May 7, 2024

2018-3854

**RE: Response to MDE “Questions for Applicant” Letter for
Proposed Chesapeake Terrace Rubble Landfill
Odenton, Maryland
Control Number 1993-WRF-0225**

LEACHATE CONTROL SUMP PUMP CONTROL PANEL AT EACH CELL

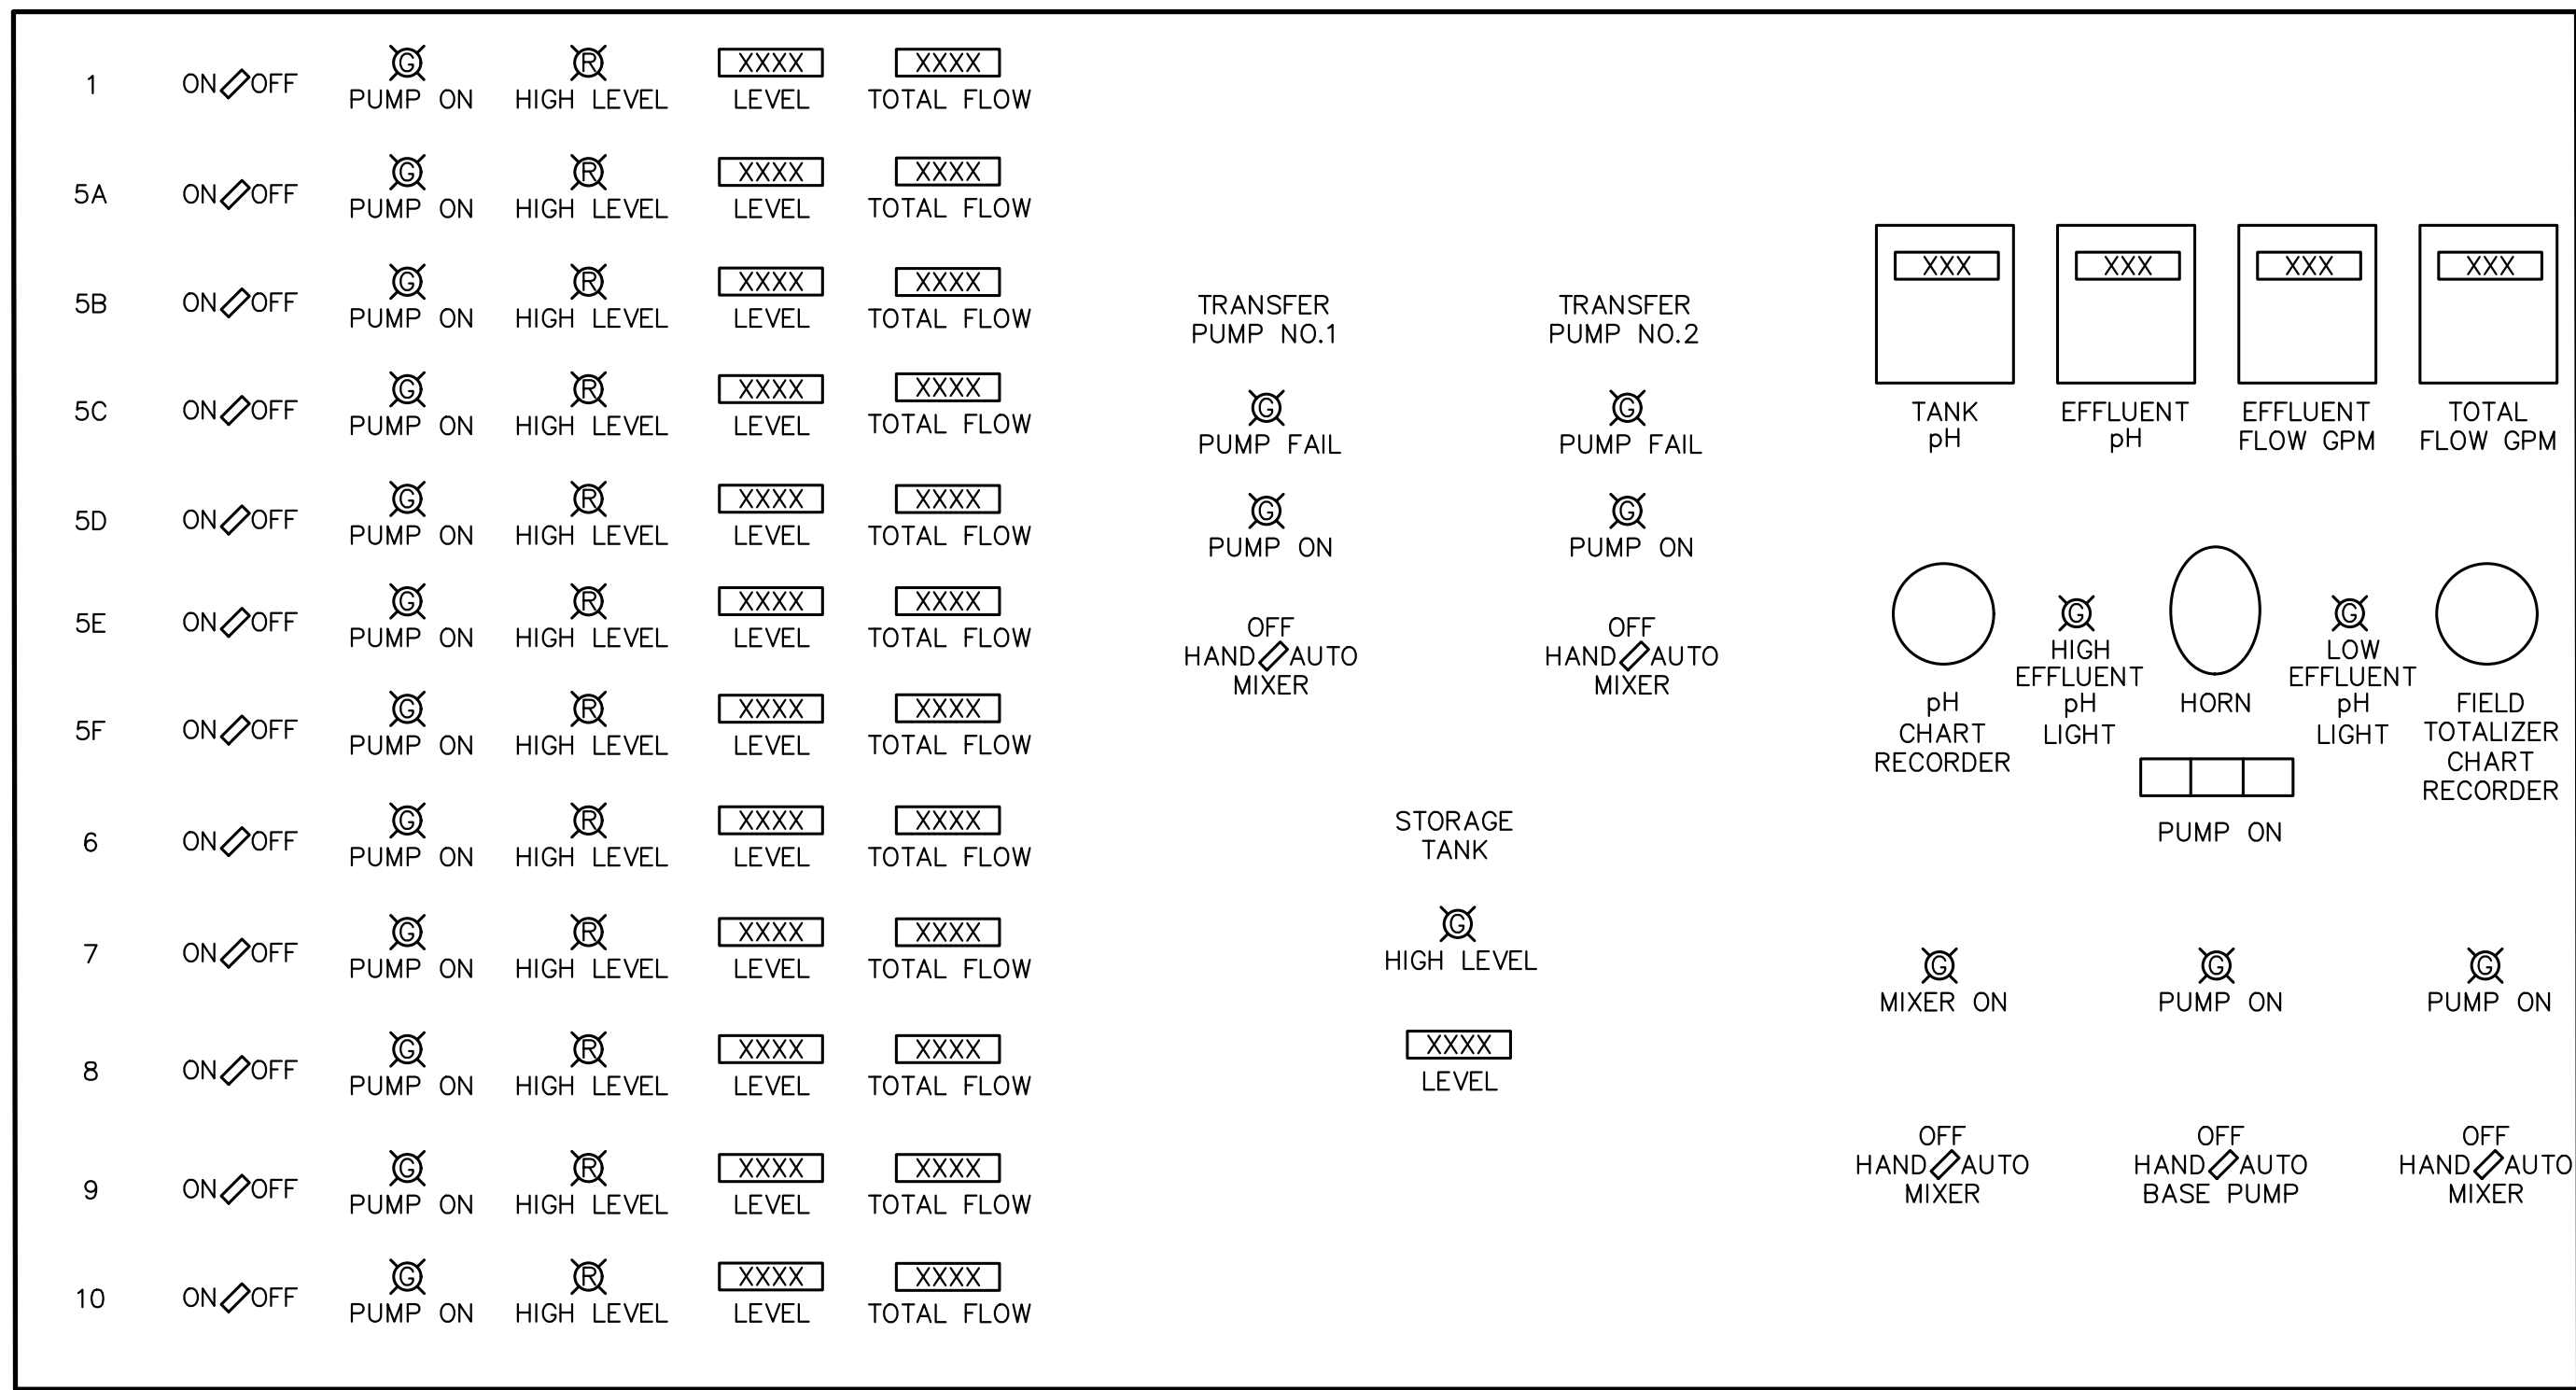
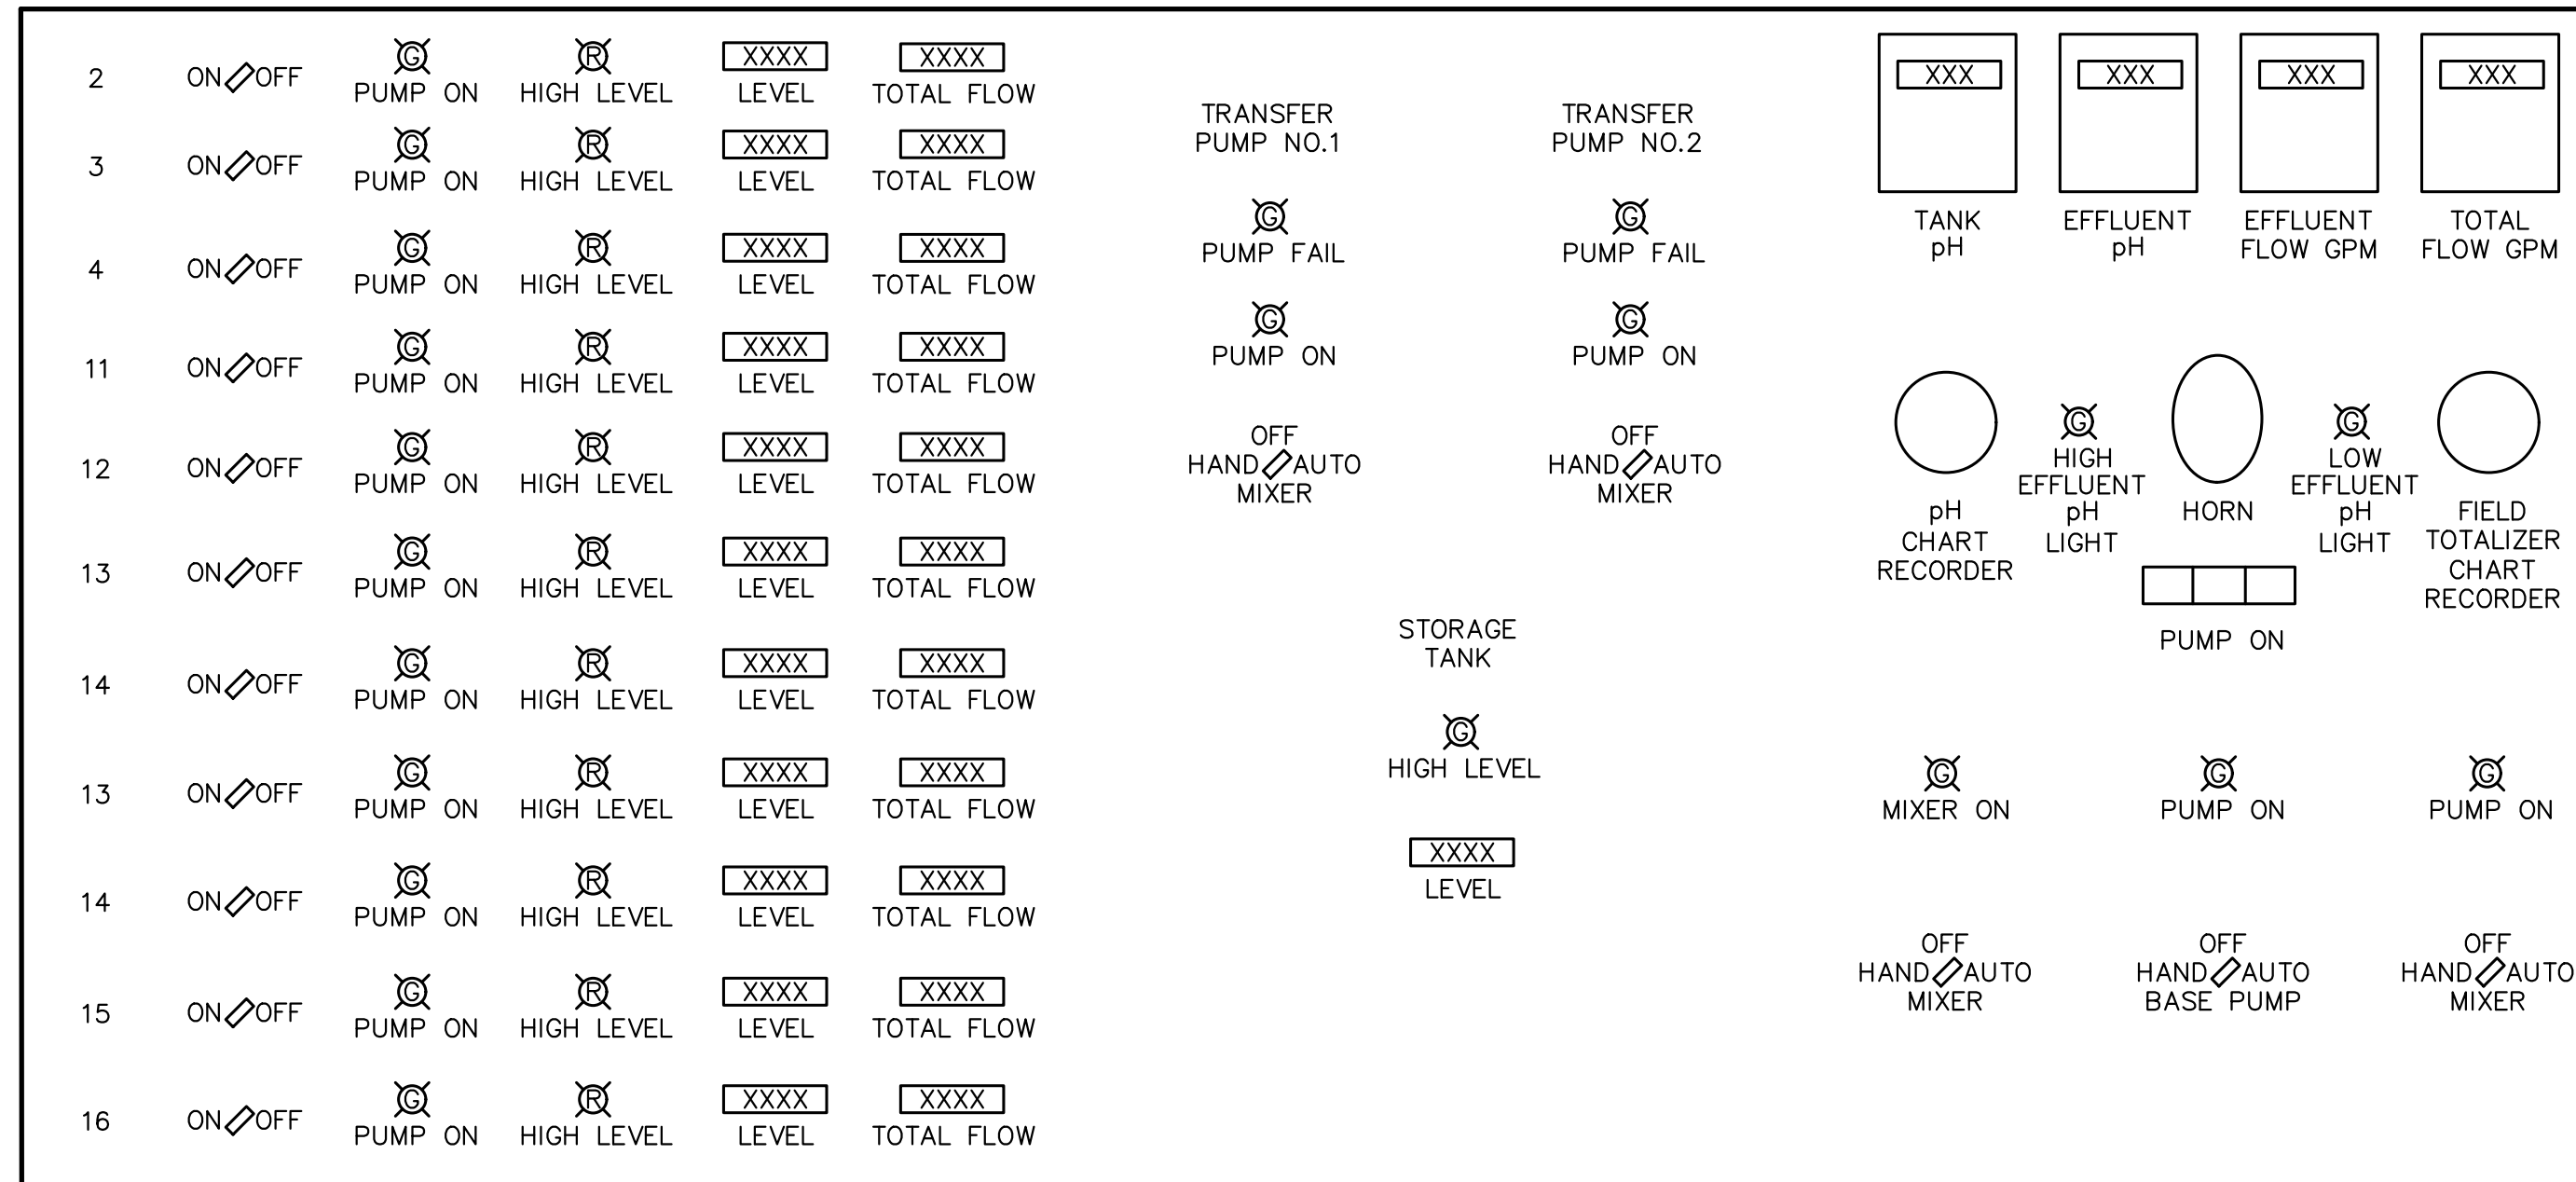
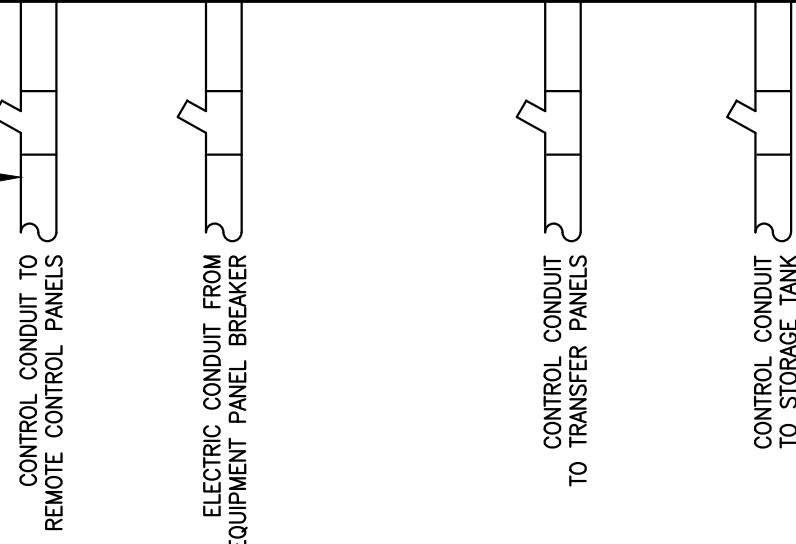
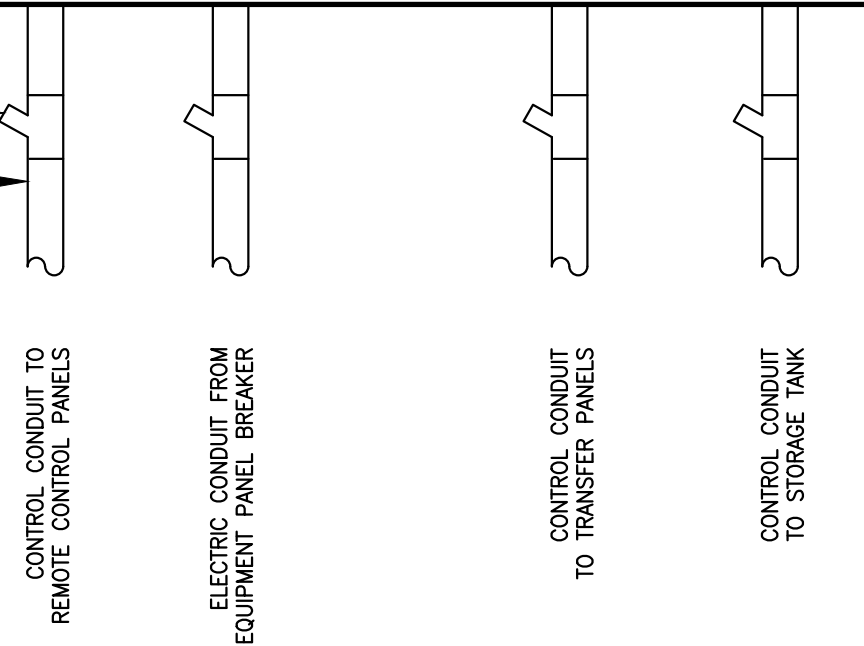
10. **MDE Comment:** Section 10.4 Leachate Pumps states "As shown on the "Cell Pump List" on Drawing 27 and in Section 10.9.3, one pump in each cell sump is sufficient to remove leachate under the peak daily generation scenario, described further in Section 10.9. A spare pump will be provided during construction of each cell for storage in the associated Leachate Pump House for immediate installation when the installed pump needs annual servicing or malfunctions." MDE requires two pumps in a sump for the low flow/high flow conditions and for redundancy. Please correct the design to include two pumps per cell.

11. **MDE Comment:** In Section 10.4 Leachate Pumps, please confirm and state in the Report that the selected pumps are explosion proof and are grinder pumps or other pumps capable of handling biological solids.

12. **MDE Comment:** Please clearly demonstrate in Appendix 10F Leachate Pump Sizing Calculations the head loss through the flexible pump discharge hose and couplings and other transitions, fittings, and valves in the hydraulic calculations. Currently, only the friction loss through the 6-inch force main is provided.

NWM Response: We have modified the text in Section 10 to state that as required by MDE duplicate pumps shall be installed in each sump. This does not require modification of the design as all sumps were designed to accommodate 2 pumps. A complete copy of the revised Section 10 "Leachate" text is attached to this letter.

NWM Response: The EPG pumps specified are intended for use in landfill leachate sumps and are suitable for use in Class I, Division 1 hazardous classified locations pursuant to National Electric Code (NEC), Article 50 1-8 condition 4 requirements and is designed to be submerged in a liquid that is flammable when vaporized. We have added language to the first paragraph of Section 10.4 stating that any pump substitutions shall be meet NEC 501-8 condition 4 requirements and be capable of handling biological solids. A complete copy of the revised Section 10 "Leachate" text is attached to this letter.

NWM Response: The Leachate Pump Sizing Calculations in Appendix 10F have been revised to include the friction loss through the 2" line from the bottom of the leachate sump to the connection with the 6" carrier pipe. We have accounted for the head loss through the various elbows and connections in both the 2" and 6" lines utilizing the Crane Co. Technical Paper 409 Equivalent Pipe Length Technique (Based on Hazen-Williams Formula) where various connections and valves are assigned an equivalent pipe length that is subsequently added to the pipe lengths when calculating friction loss. The resulting calculations, shown in the revised Appendix 10F Table (attached to this letter as Response to Comment 12), prompted an increase in the pump sizes for Sumps 9, 10, 13, 14 and 16. In addition to the Table in Appendix 10F, the design head and/or model of the pumps appear in Drawing 27 and Table 5 in Section 10.9.3. The revised Drawing 27 and copy of the revised Text for Section 10
